Location:	West Oakland BART – 1451 7th Street (PUD Development Site T3)
Assessor’s Parcel Numbers:	004-0077-003-00 & 004-0071-003
Proposal:	Proposed design modifications to the T3 Final Development Plan site for the Mandela Station PUD. As required by Condition of Approval #77 for case file number PLN18490-R01-PUDF03, the applicant is returning to the DRC for review of the final design of the northern wall facing the BART tracks. In addition, the applicant has requested a Determination pursuant to Condition of Approval #4 that other design modifications being proposed are deemed “Minor” and do not require submittal of a Revision Application or new Development Application.
Applicant:	Mandela Station Affordable LP
Owners:	San Francisco Bay Area Rapid Transit District (BART)
Planning Permits Required:	Not Applicable – Final Development Plan was previously approved.
General Plan:	Community Commercial

CITY OF OAKLAND PLANNING COMMISSION

Case File: PLN18490-R01-PUDF03 & DET240128
Applicant: Alan Dones
Address: 1451 7th Street - West Oakland BART
Base Zone(s): S-15W
Combining Zone(s): S-13, S-14
Height Area(s): 65 ft, 175 ft

Project: Mandela Station Affordable at West Oakland BART
PLN1

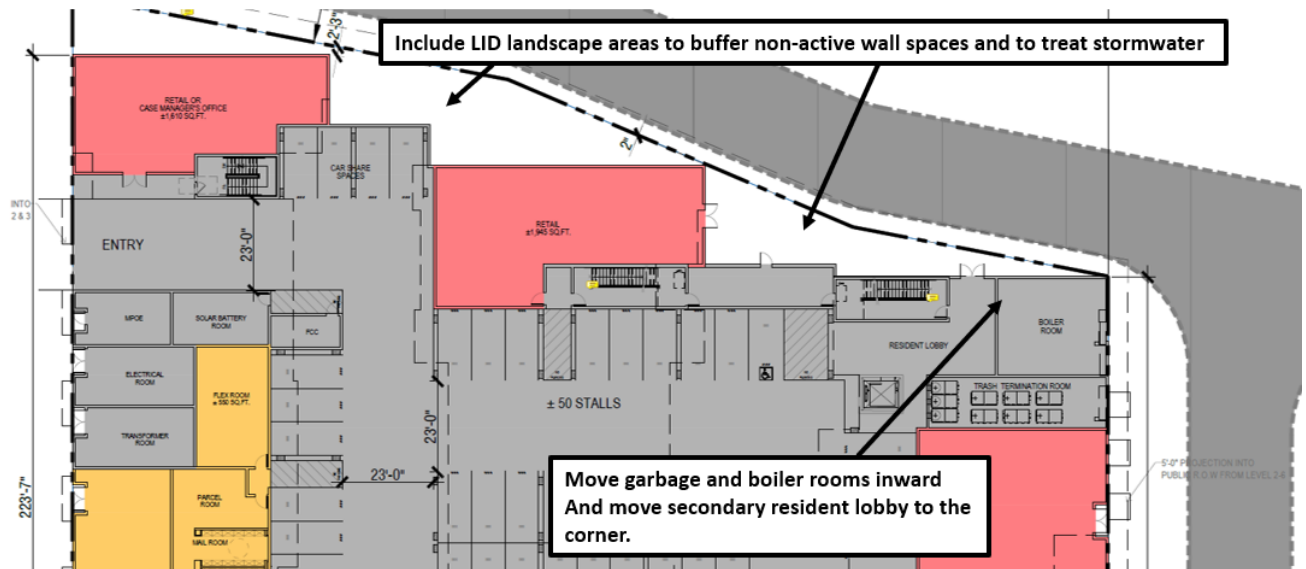
At this time the applicant has determined that the rotating art wall is infeasible as an ongoing cost tied to the management of an affordable housing development. However, the applicant is still looking to use the northern wall as an elevation that can accommodate rotating art installations, but they are looking to separate it from the requirement under the municipal code. The current request is to provide the required public art on other building elevations, primarily at the corner of 5th Street at the paseo entry. Given the current proposal, staff is bringing the item back to the DRC per the condition of approval since there will be periods of time (or possibly not at all) where there will not be art installed on the northern elevation. Staff is supportive of the request to relocate the permanent public art since it will be well served at the paseo entry and since the northern wall is still being designed in a manner that could accommodate art installations down the road, even if not part of a requirement by the City. In addition, staff feels that the northern wall has been designed in a manner that is acceptable as a standalone elevation without the public art given that it is the back wall facing the BART tracks. The proposal is also consistent with other recently approved development projects in the vicinity adjacent to the BART tracks. The current proposal continues to provide the same color palette as previously approved and includes additional massing breaks into the façade while still providing a sound wall to buffer the open space courtyard from the noise of passing BART trains. With this, staff feels that the applicant has met the intent of the condition of approval and seeks concurrence from the DRC.

1. PROPOSED NORTH ELEVATION

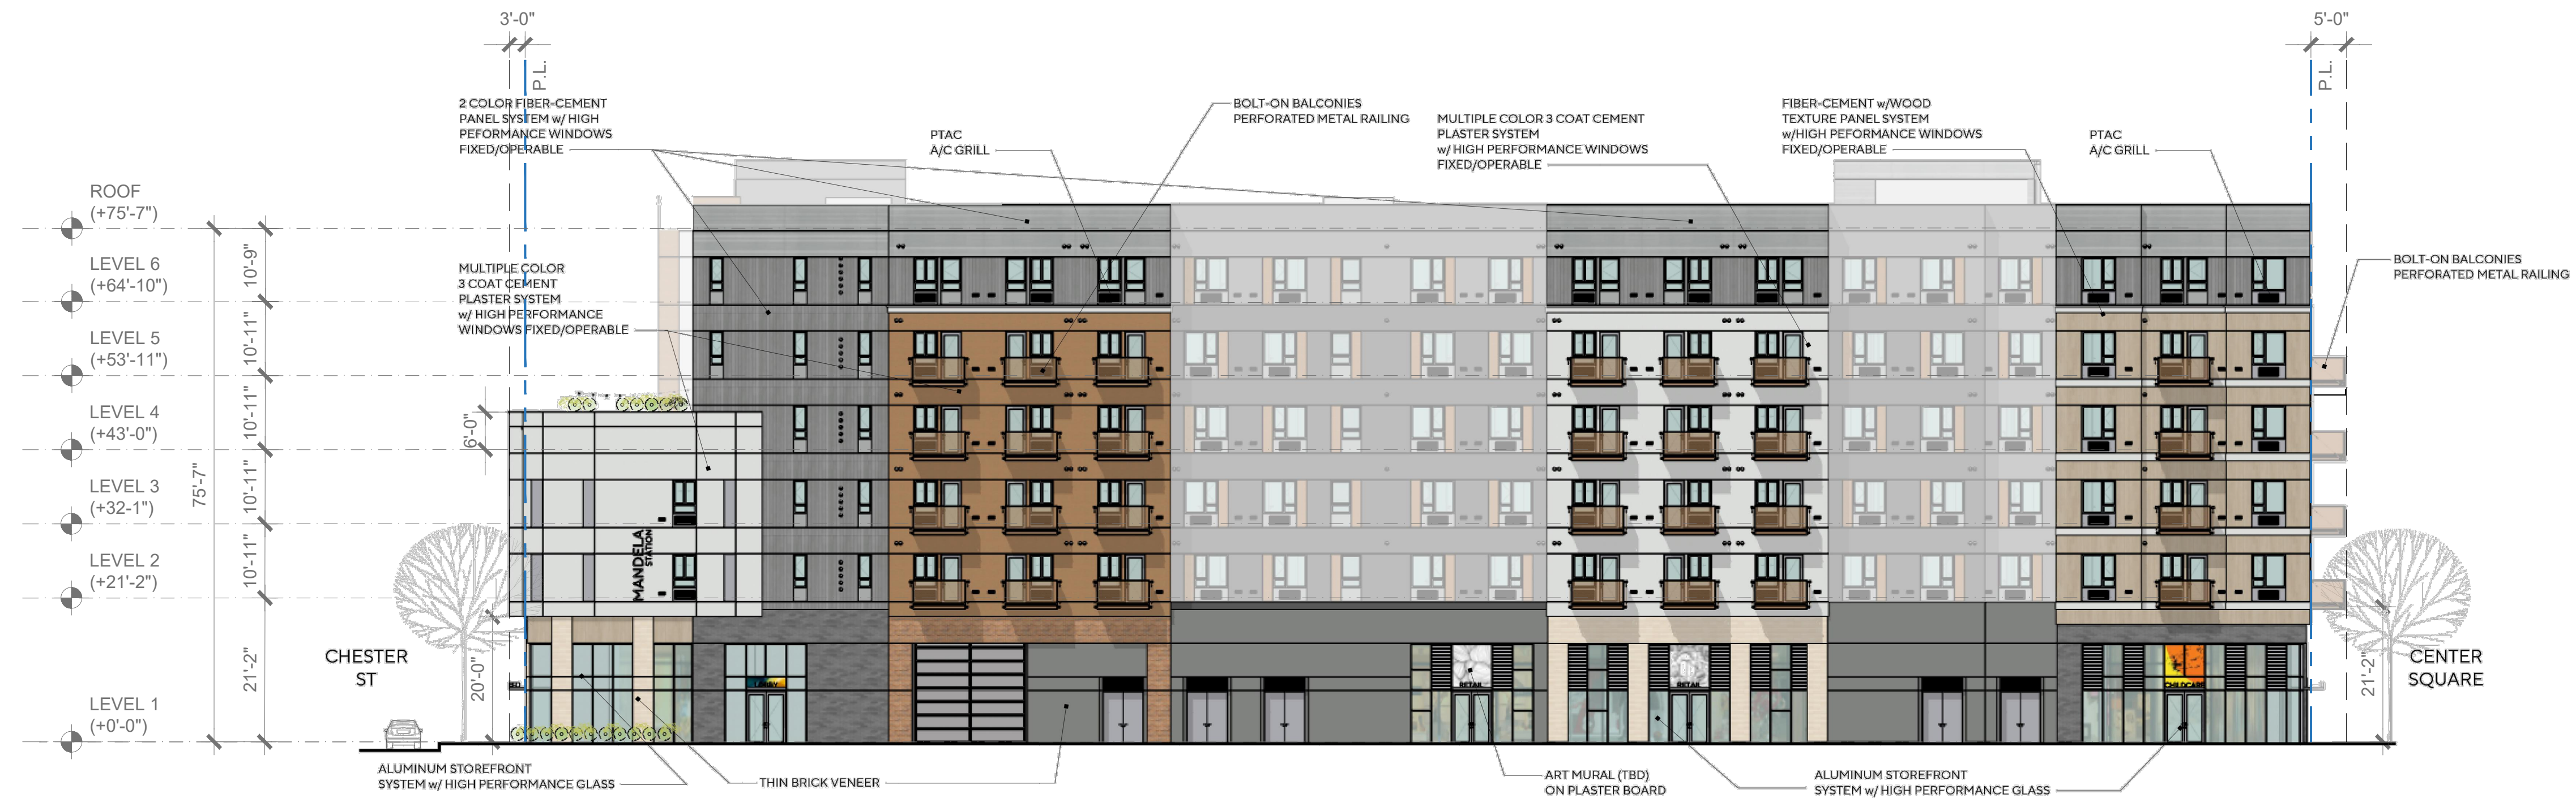
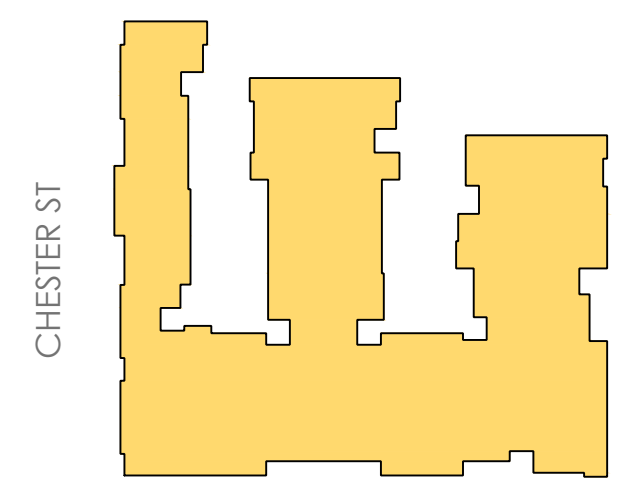
BART Aerial Façade

In addition to the design modification to the “art wall” on the upper building elevations, there have been modifications to the ground floor elevation of the northern façade as well. The prior design included a fairly continuous frontage of ground floor retail, whereas the current proposal includes a number of areas of relatively bank walls to accommodate utilities and garage ventilation. Staff recommends that the areas facing the tracks that include non-active uses be further buffered by landscape areas that could also double as areas to provide for LID treatment for stormwater. Staff also would like to see the internal garbage collection area and boiler room recessed back and flipped with the exist stair to establish a secondary lobby for residents that opens onto the BART paseo so that an active use is established at that prominent corner.
